Subject: Exhaust Pipe and Cab Support Bracket Interference

Models Affected: Specific Freightliner New Cascadia vehicles built from April 20, 2021 through August 11, 2021.

CAL FTL 49-004

Figure 1: Installation Diagram Vertical Exhaust

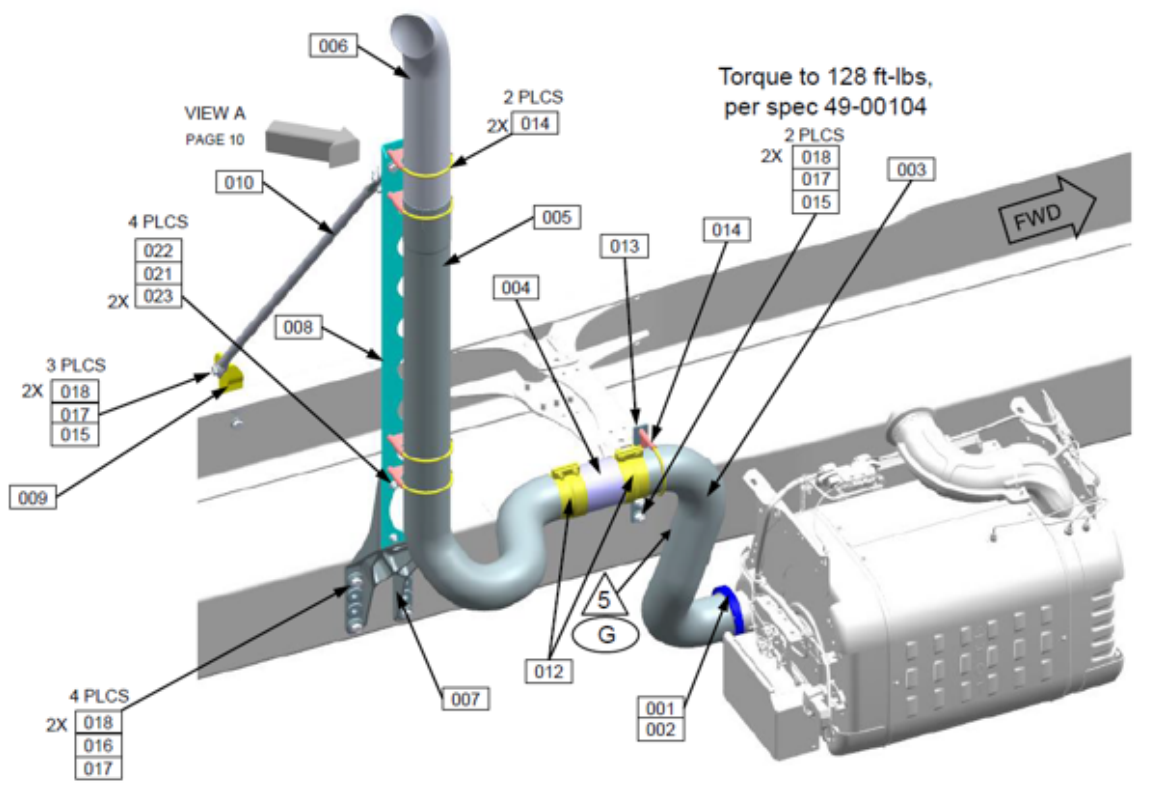
- Referencing **Fig. 1** (from installation diagram D04-31766-007), remove the lower clamps numbered 14 and 12.

- Remove the exhaust pipe bracket, labeled as item 13 in **Fig. 1** (from installation diagram D04-31766-007).

16. Confirm there is no interference between the exhaust pipe and the lower cab support bracket.
17. Install the flex pipe and clamps (item 12 in **Fig. 1**); tighten the clamps 38 to 45 lbf•ft (45 to 55 N•m).
18. Tighten the four vertical exhaust pipe saddle clamps to 23 ± 3 lbf•ft (31 ± 3.5 N•m).
19. Install the exhaust shield, tighten the mounting bolts 11 lbf•ft (15 N•m).
20. Inspect the final installation; it should look like **Fig. 9**.

Figure 2: Exhaust Pipe Mounting Bracket Trimming

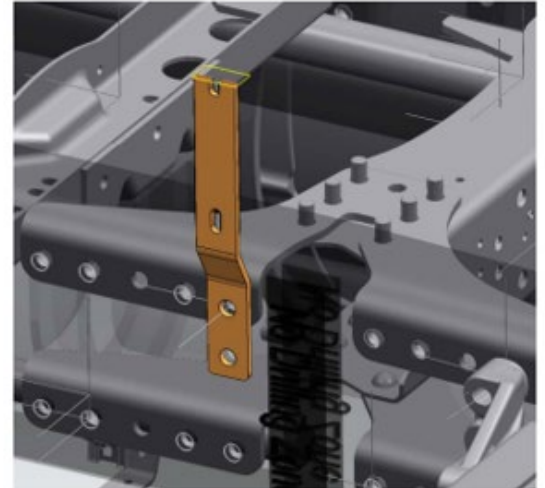
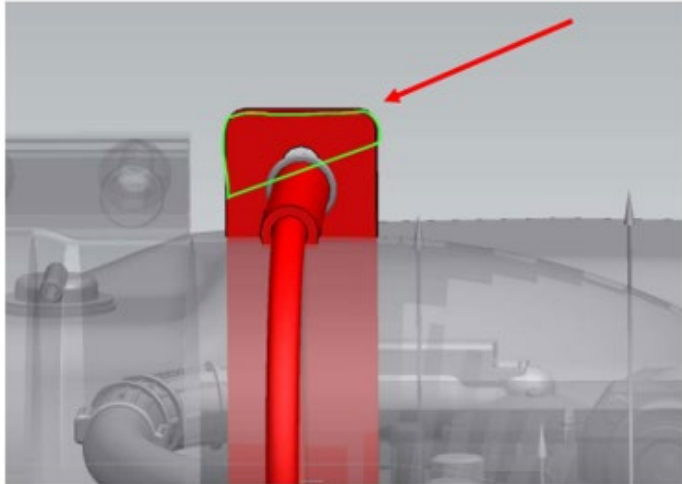
- Trim the bracket along the green lines as shown in **Fig. 2**.

- Install the trimmed bracket using the hex bolts (23-14067-060), adding 3 additional washers (23-14091-007) at each bracket mounting point to separate it from the frame rail. This will result in moving the pipe to a new position. Torque to 128 lbf•ft (174 N•m).
- Install the clamp, item 14 in **Fig. 1**, removed in step 2. Tighten only hand tight as shown in **Fig. 3**.

Figure 4. Upper (Item 14) and lower (Item 1) Exhaust Clamps shown.

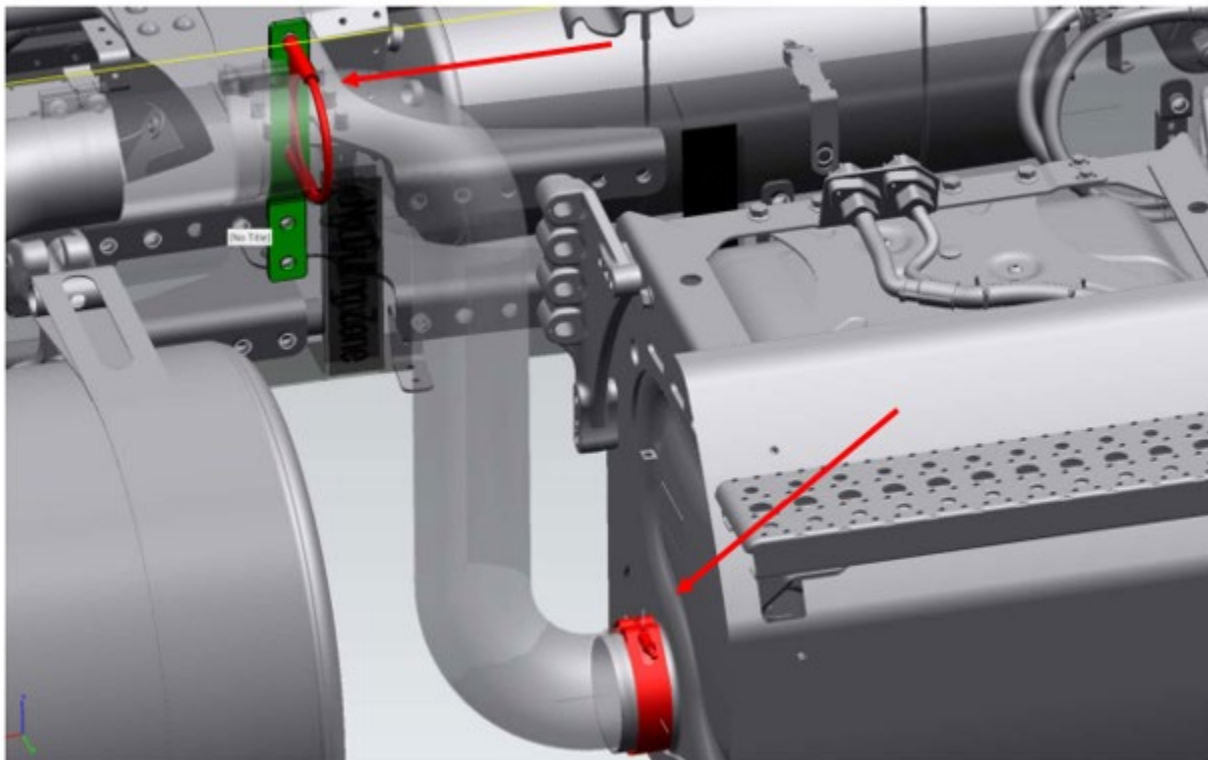
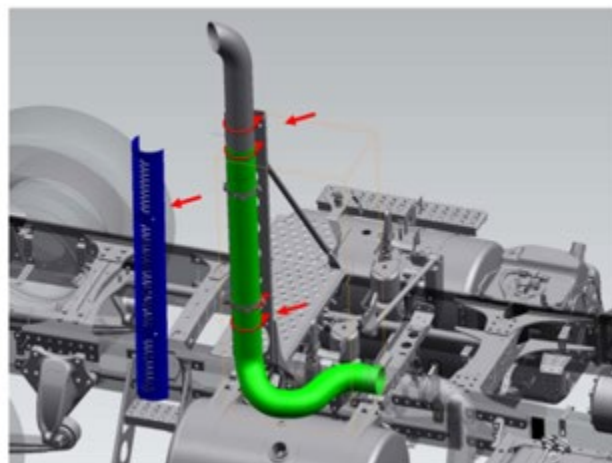
7. Loosen the lower exhaust clamp shown in red in **Fig. 4**.

8. With the lower exhaust clamp loosened, tighten the upper exhaust clamp (item 14 in **Fig. 4**) to 23 ± 3 lbf•ft (31 ± 3.5 N•m).
9. Tighten the lower exhaust clamp (item 1 in **Fig. 4**) to 15 ± 0.5 lbf•ft (20 ± 1 N•m).
10. Remove the mounting bolts that fasten the exhaust shield and remove the exhaust shield as shown in **Fig. 5**.

Fig. 5, Exhaust Shield Removal

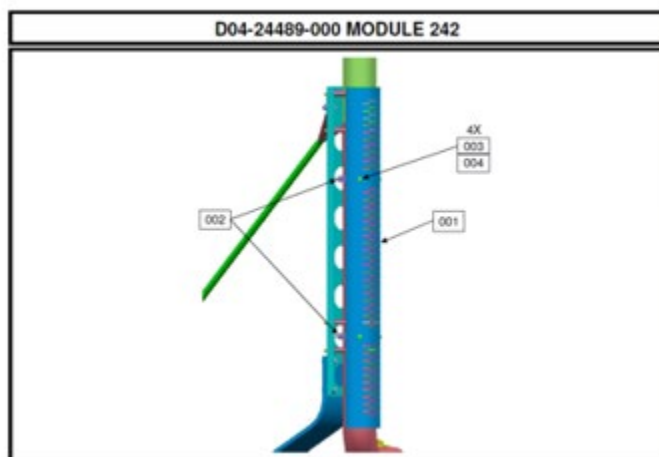
12. Loosen the four vertical exhaust pipe saddle clamps called out in red in **Fig. 5**.

Figure 6. Hard Interference points.

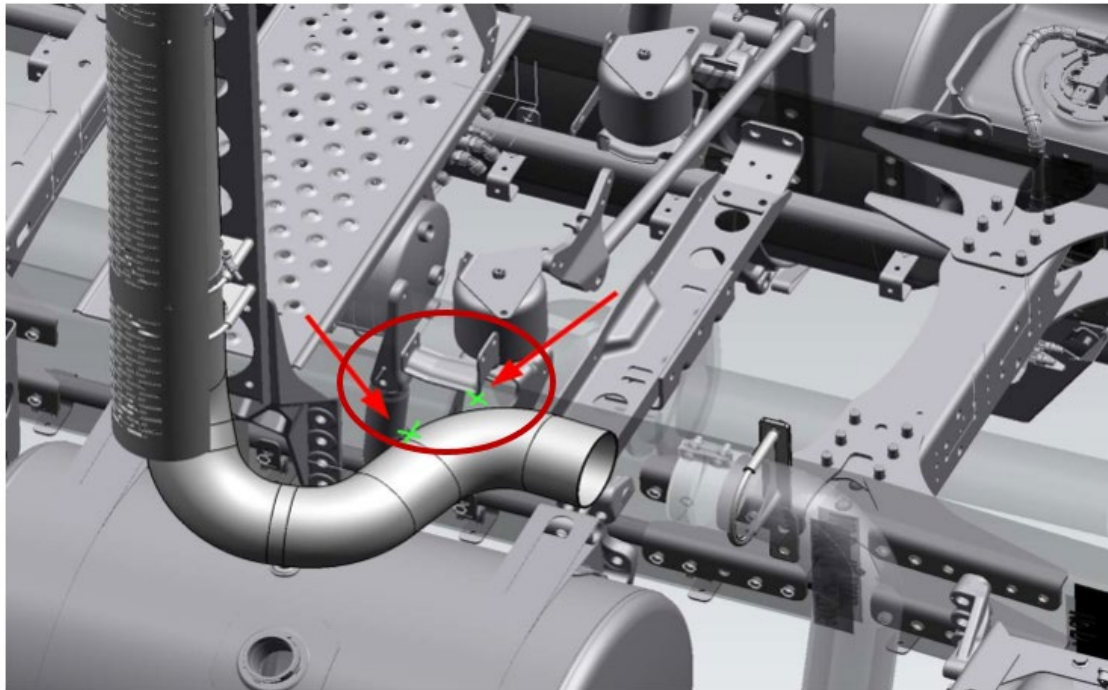
11. Inspect the area of the exhaust pipe called out in **Fig. 6** for any damage.

13. Inspect the section of the exhaust stack called out in **Fig. 6**.

13a. If the pipe is indented, replace this portion of exhaust pipe with the same part number, leaving the saddle clamps loose.

Fig. 7, Adjust the Exhaust Stack Down

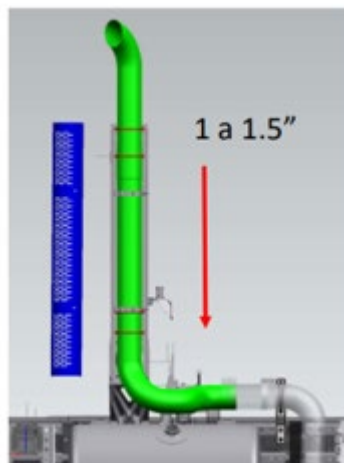
14. Adjust the position of the exhaust stack down 1 to 1.5 inches (2.5 to 4 cm) as shown in **Fig. 7**.

Fig. 8, Rotate the Exhaust Pipe Clockwise

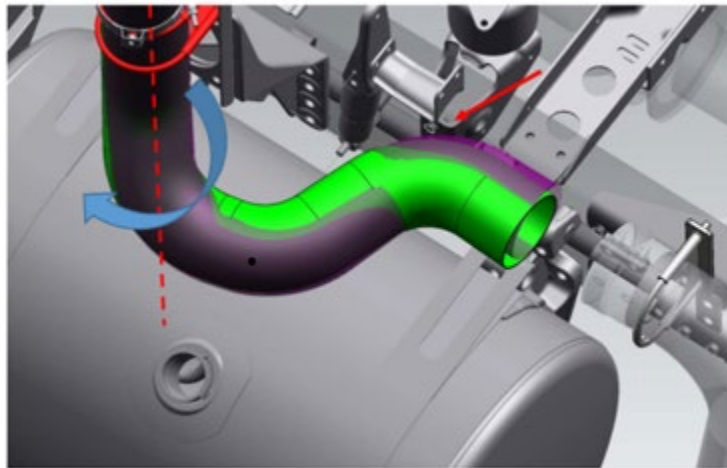
15. To increase clearance between the exhaust pipe and lower cab support bracket, rotate the exhaust pipe clockwise as shown in **Fig. 8**.

Fig. 9, Final Installation

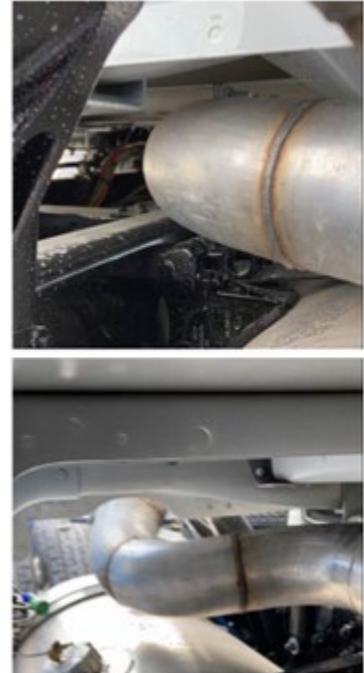
- Rotate pipes outboard
- Rework bracket
